PROPOSED IMPROVEMENT BRIDGE PROJECT

ROUTE NO. : US ROUTE 2 BRIDGE NO. : 8
PROJECT LOCATION : LOCATED ON US ROUTE 2, APPROXIMATELY 2,000 FEET NORTH OF THE
INTERSECTION OF US ROUTE 2 AND EAST SHORE NORTH OVER LAKE CHAMPLAIN.

PROJECT DESCRIPTION : INTERIM DRAWBRIDGE REPAIRS – WORK PACKAGE II
LENGTH OF STRUCTURE : 258.80 FEET.

SUBMITTAL REVIEW	
VTRANS North Hero - Grand Isle BF EWP1(2)	
Submittal #0044	
<input checked="" type="checkbox"/>	APPROVED - APP
<input type="checkbox"/>	APPROVED AS NOTED - ANR
<input type="checkbox"/>	> CONSTRUCTION MAY PROCEED WITH ANR
<input type="checkbox"/>	> RESUBMITTAL REQUIRED FOR DOCUMENTATION ONLY
<input type="checkbox"/>	FOR RECORD ONLY - FRO
<input type="checkbox"/>	REVISE & RESUBMIT - RR
<input type="checkbox"/>	> CONSTRUCTION MAY NOT PROCEED
<input type="checkbox"/>	> RESUBMITTAL REQUIRED - RR
<input type="checkbox"/>	REJECTED - NA
<input type="checkbox"/>	> CONSTRUCTION MAY NOT PROCEED
<input type="checkbox"/>	> RESUBMITTAL REQUIRED - RR
<input type="checkbox"/>	REVIEWED WITH NO COMMENTS - RWNC
REVIEW IS FOR GENERAL COMPLIANCE WITH CONTRACT DOCUMENTS. SOLE RESPONSIBILITY FOR CORRECTNESS OF DIMENSIONS, DETAIL QUANTITIES AND SAFETY DURING FABRICA

TITLE: 8MBTE-0200-AA-ED30-RHR-M7-SPL
 OUTLINE DRAWING

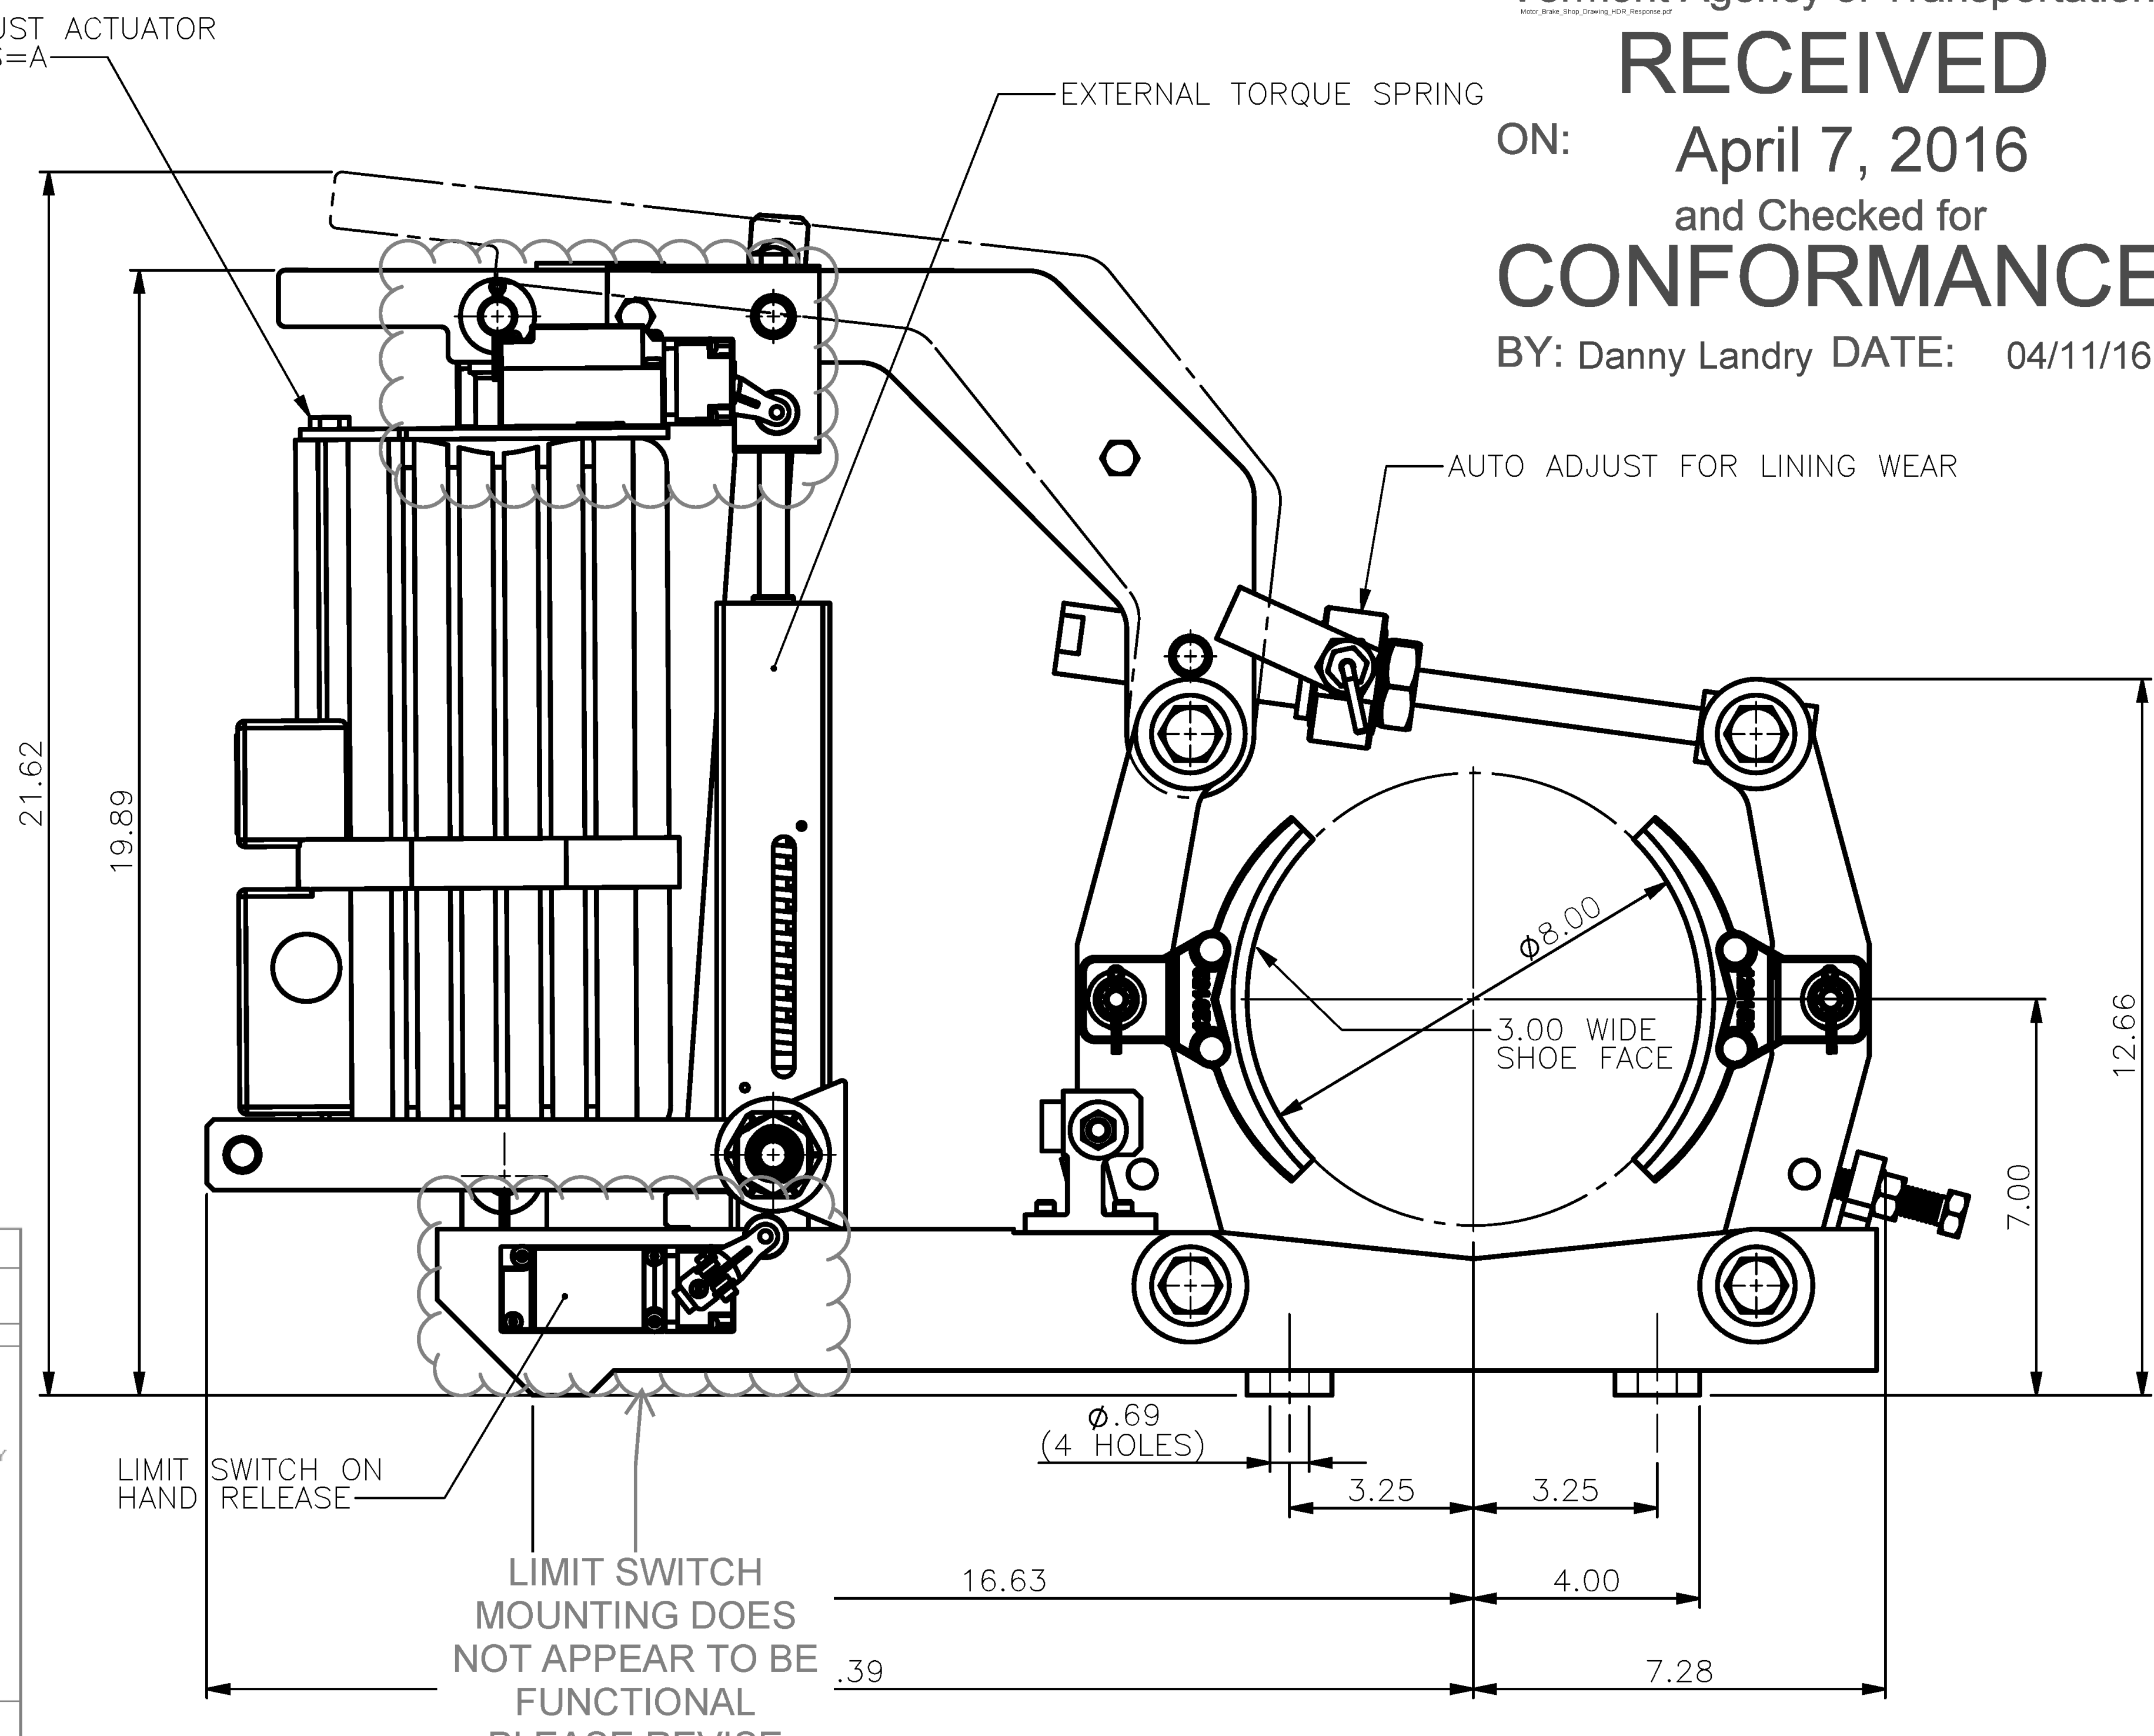
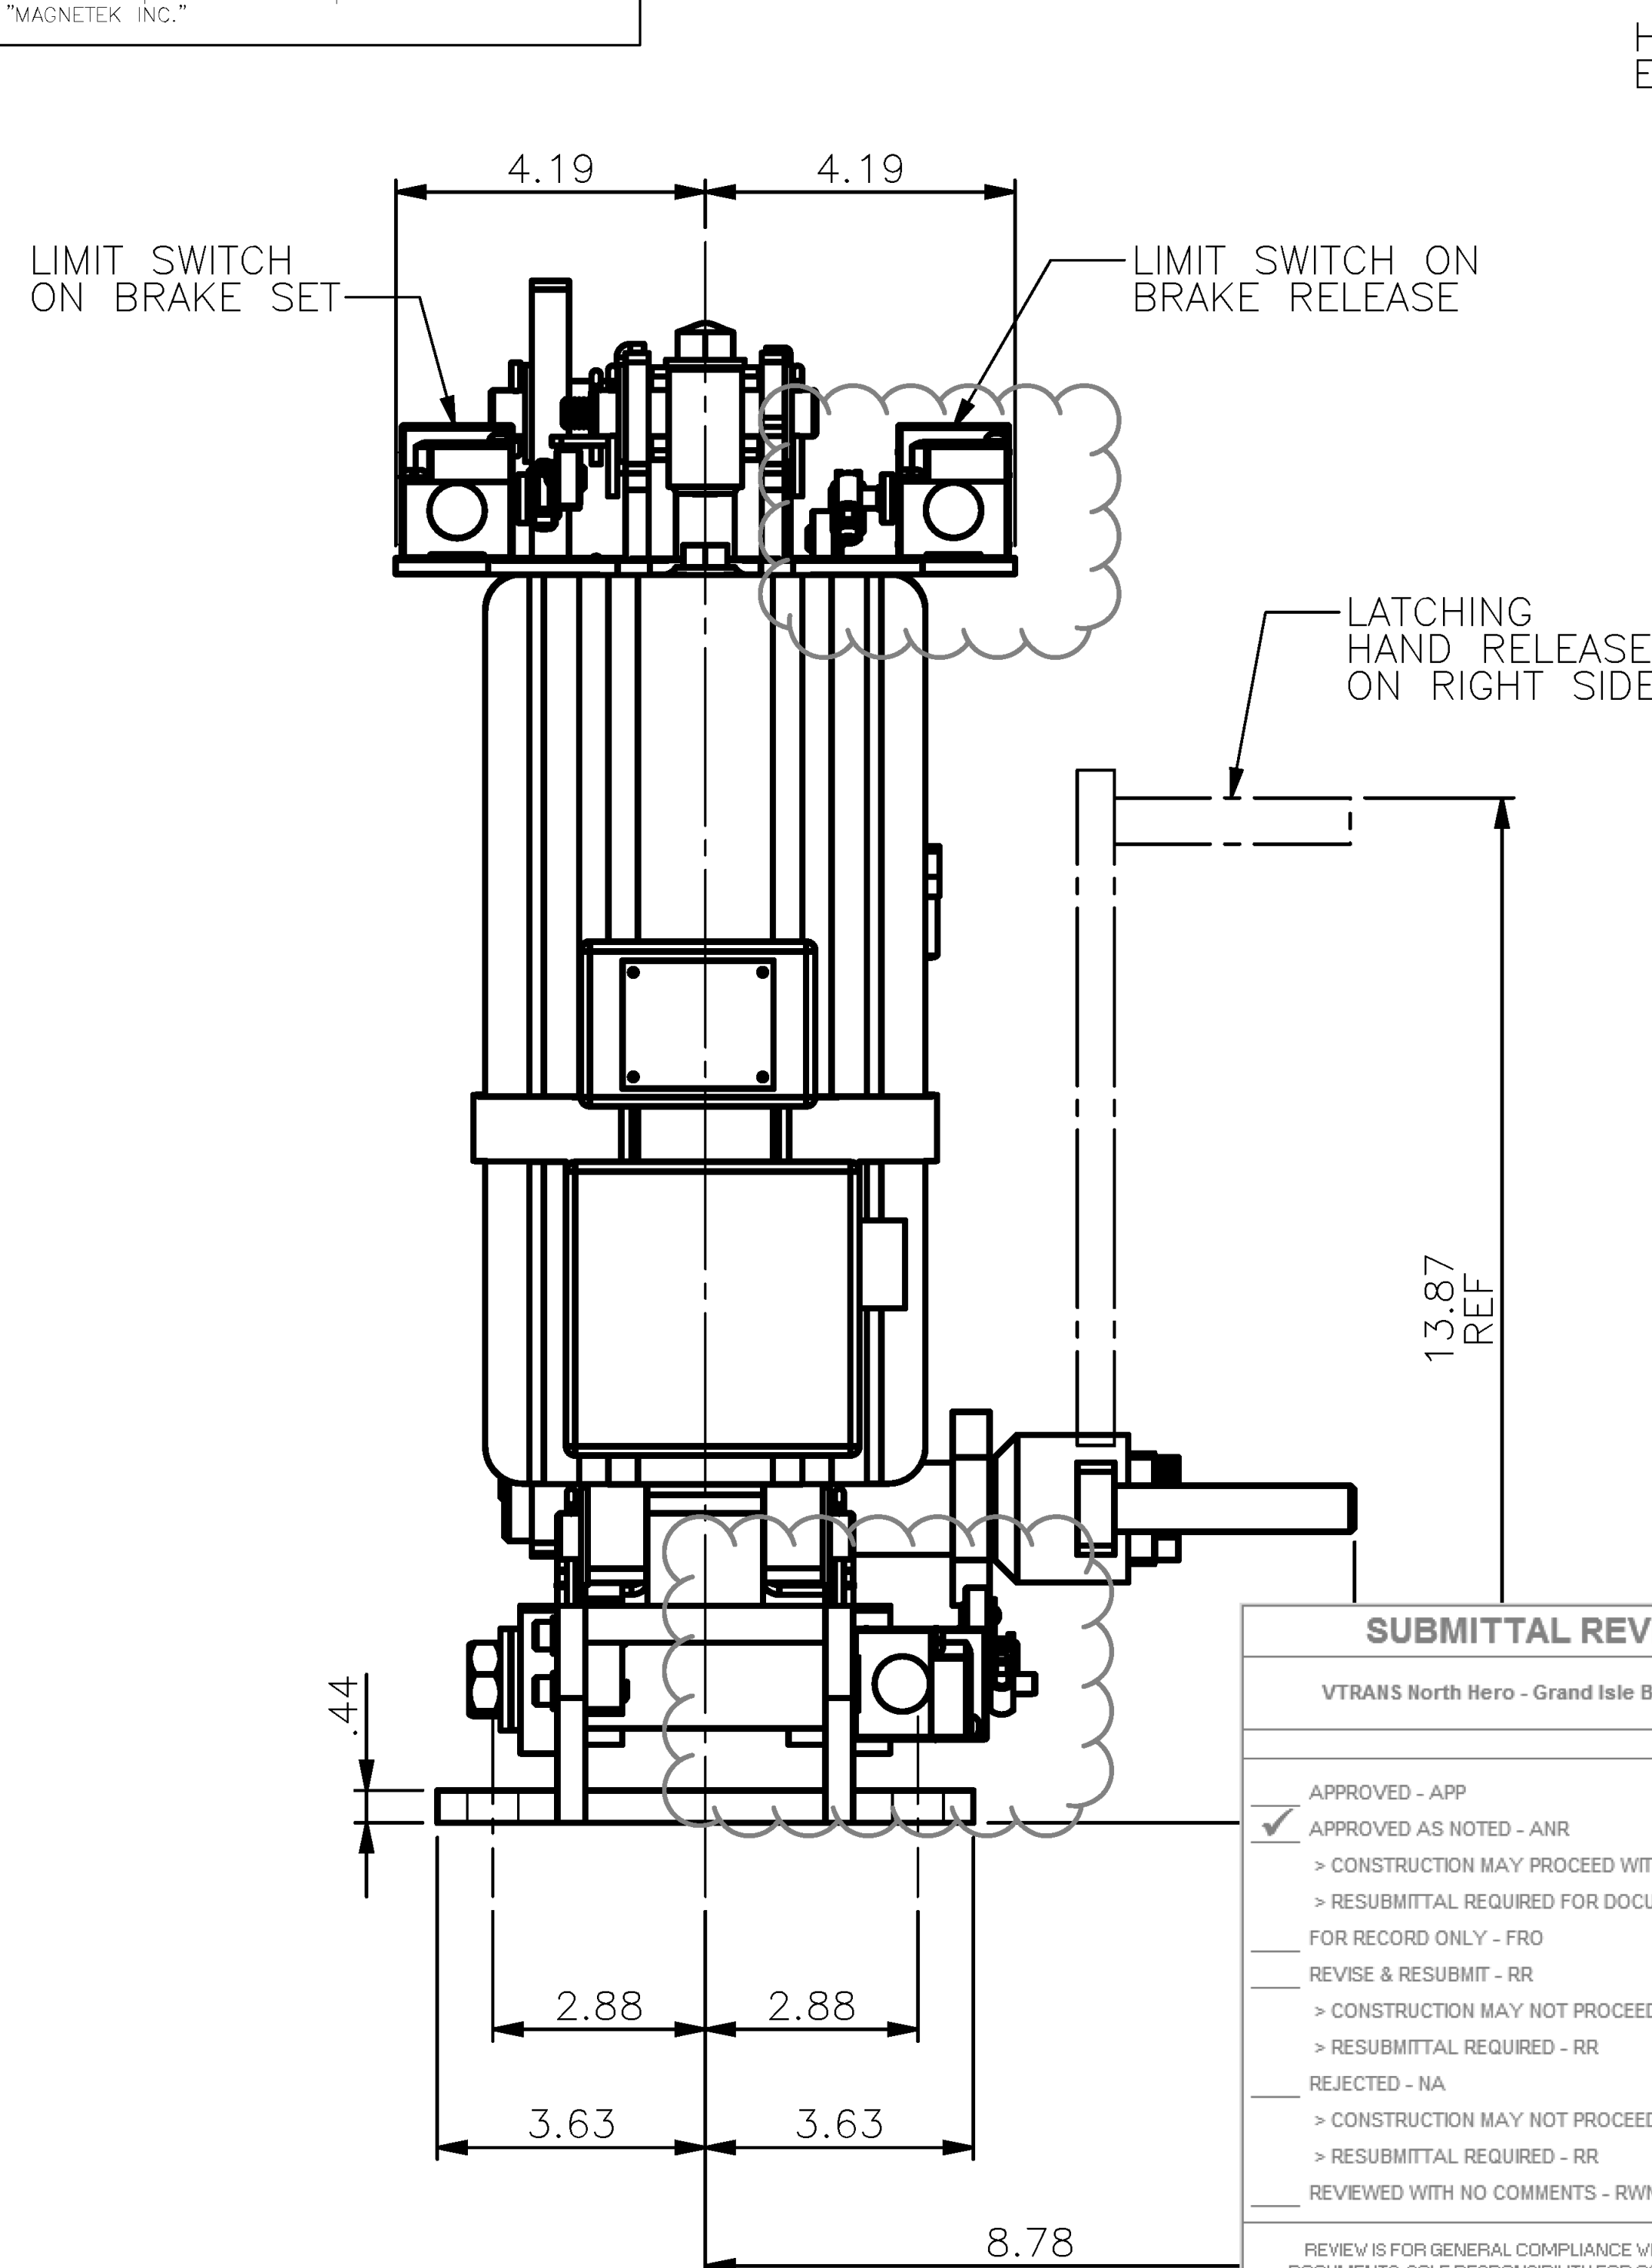
PROVIDE BRAKE TORQUE SETTING
